Well Name: PENNZOIL FED	Well Location: T19S / R33E / SEC 12 / SENE / 32.67648 / -103.610169	County or Parish/State: LEA / NM
Well Number: 02	Type of Well: CONVENTIONAL GAS WELL	Allottee or Tribe Name:
Lease Number: NMNM4312	Unit or CA Name:	Unit or CA Number:
US Well Number: 3002526499	Operator: EARTHSTONE OPERATING LLC

Type of Submission: Notice of Intent Type of Action: Plug and Abandonment

Procedure Description: Earthstone Operating, LLC respectfully requests approval of the attached plug and abandon procedure for the Pennzoil Fed #2. Attachments: P&A Procedure Current WBD Proposed WBD

Proposed P&A NOI
Earthstone Operating, LLC
Pennzoil Operating, LLC
30-025-26499

Permian Resources (Earthstone Operating, LLC)				PROPOSED	
Author:	Abby @ JMR			Well No.	#2
Well Name	Pennzoil Federal			API #:	30-025-26499
Field/Pool	Quail Ridge; Morrow, Nth (Gas)			Location:	1980 FNL & 660 FEL
County	Lea				Sec 12, T19S, R33E
State	NM			GL:	3776
Spud Date	11/4/1979

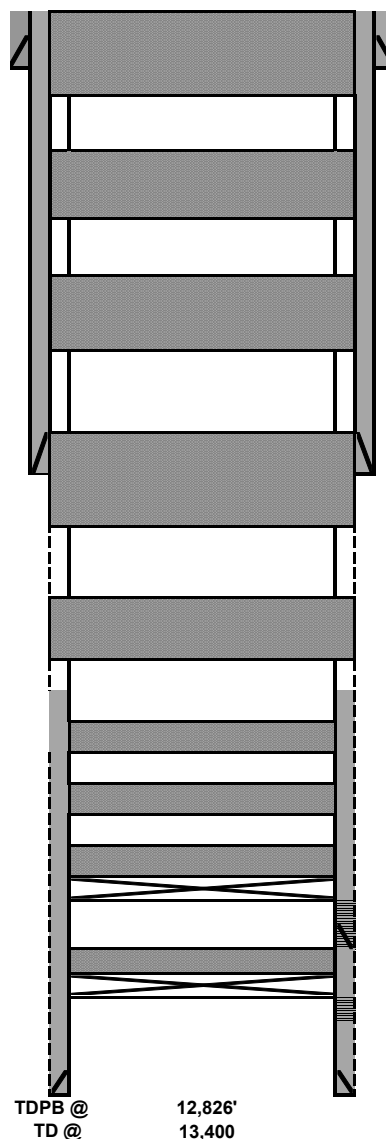
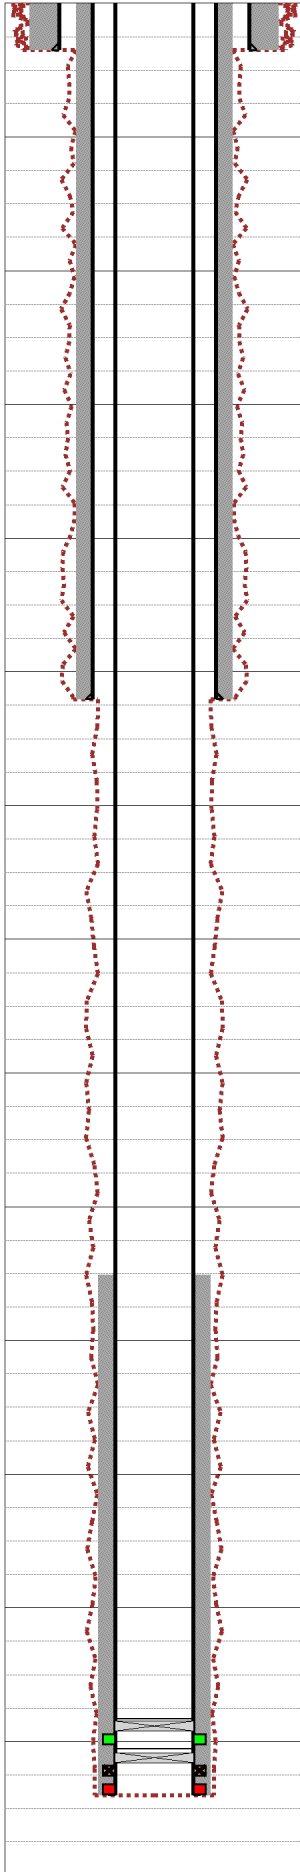
4. Circulate hole & pressure test casing to 500 psi. **Spot 28 sxs on top of CIBP. WOC and Tag.**
5. **Plug #1: (Atoka & Strawn):** Spot **59** sxs class H cmt @ 12,335-11,857'.

6. **Plug #2: (Wolfcamp):** Spot **29** sxs class H cmt @ 10,800-10,567'. **WOC and Tag.**
7. **Plug #3: (Bone Springs):** Perf & Sqz **56** sxs class H cmt (34 sxs outside, **22** sxs inside) @ 7568-7392'.

8. **Plug #4: (8 5/8" Shoe & San Andres):** Perf & Sqz **240** sxs class C cmt w/ 2% CaCl (**138** sxs outside, **102** sxs inside) @ **5,350-4,327'**. WOC & Tag

9. **Plug #5: (Yates & B/Salt):** Perf & Sqz 201 sxs class C cmt w/ 2% CaCl (143 sxs outside, 58 sxs inside) @ 3,310-2,780'. WOC & Tag.
10. **Plug #6 (Rustler & T/Salt):** Perf & Sqz **91** sxs class C cmt w/ 2% CaCl (**52** sxs outside, **39** sxs inside) @ 1,881-1,495'. WOC & Tag.

Spot 28 sxs on top. WOC and
Tag. Leak test CIBP.

7. Plug #6: Perf & Sqz 91 sxs class C cmt w/ 2% CaCl (52 sxs outside, 39 sxs inside) @ 1,881-1,495'. WOC & Tag (Rustler & T/ Salt)

5. Plug #4: Perf & Sqz 240 sxs class C cmt w/ 2% CaCl (138 sxs outside, 102 sxs inside) @ 5,350-4,327'. WOC & Tag (8 5/8" Shoe & San Andres)

4. Plug #3: Perf & Sqz 56 sxs class H cmt (34 sxs outside, 22 sxs inside) @ 7568-7392'. (Bone Springs)

3. Plug #2: Spot 29 sxs class H cmt @ 10,800-10,567'. WOC and Tag.

2. Plug #1: Spot 59 sxs class H cmt @ 12,335-11,11857'. WOC and Tag.
